Access Compliance Report

Public Rights-of-Way

(Curb Ramps)

Intersection ID: 28112	Main Street: PROVIDENCE_RD	Cross Street: BELICOURT_DR	Location: NE
ADA ID: 6FDADD5155D2	Ramp Type: Para	Initial Pass/Fail: Fail	Overall Compliance: No
Severity Score: 12.5			
Codes/Mitigation Info/Possible Solution		Field Measurements/Component Compliance

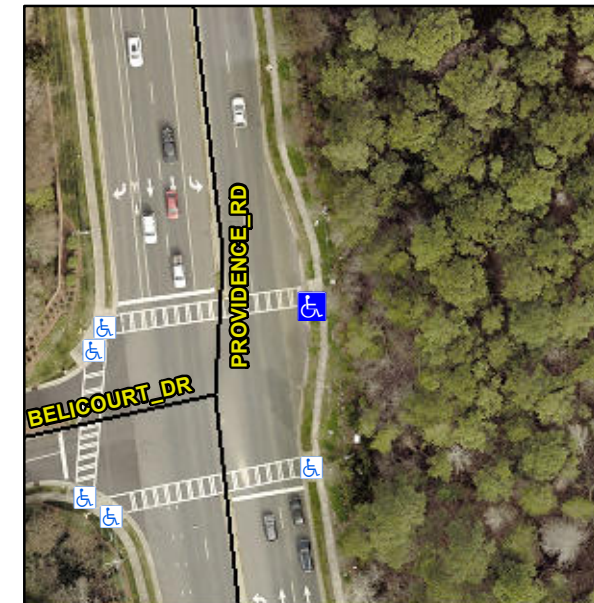
RT RP < 5%

R304.3.2

Compliance	Description	Data	Compliance	Description	Data
N/A	Ramp Length LT (in)	59.0	N/A	Ramp Length RT (in)	71.0
Yes	Ramp Width LT (in)	59.0	Yes	Ramp Width RT (in)	59.0
No	Ramp Slope LT (%)	11.6	Yes	Ramp Slope RT (%)	1.7
Yes	Ramp XSlope LT (%)	1.7	Yes	Ramp XSlope RT (%)	0.4
N/A	Landing Length (in)	N/A	N/A	DWS Provided?	N/A
N/A	Landing Width (in)	N/A	N/A	DWS Contrast?	N/A
N/A	Landing Slope (%)	N/A	N/A	DWS Length (in)	N/A
N/A	Landing X Slope (%)	N/A	N/A	DWS Full Width?	N/A
N/A	Landing Curb? (Y/N)	N/A	N/A	DWS Offset (in)	N/A
N/A	Shared Landing?	N/A			
N/A	Gutter Ponding?	N/A	N/A	Gutter Slope (%)	N/A
N/A	Gutter Lip Ht (in)	N/A	N/A	Gutter X Slope (%)	N/A
N/A	Painted X Walk1?	Yes	N/A	Painted X Walk2?	N/A
	X Walk 1 Direction	To W		X Walk 2 Direction	N/A
N/A	X Walk 1 Width (in)	104.0	N/A	X Walk 2 Width (in)	N/A
	X Walk 1 Slope (%)	3.5		X Walk 2 Slope (%)	N/A
	X Walk 1 X Slope (%)	4.1		X Walk 2 X Slope (%)	N/A
N/A	Ramp inside XWalk1?	Yes	N/A	Ramp inside XWalk2?	N/A

Remove & Replace Entire Ramp.
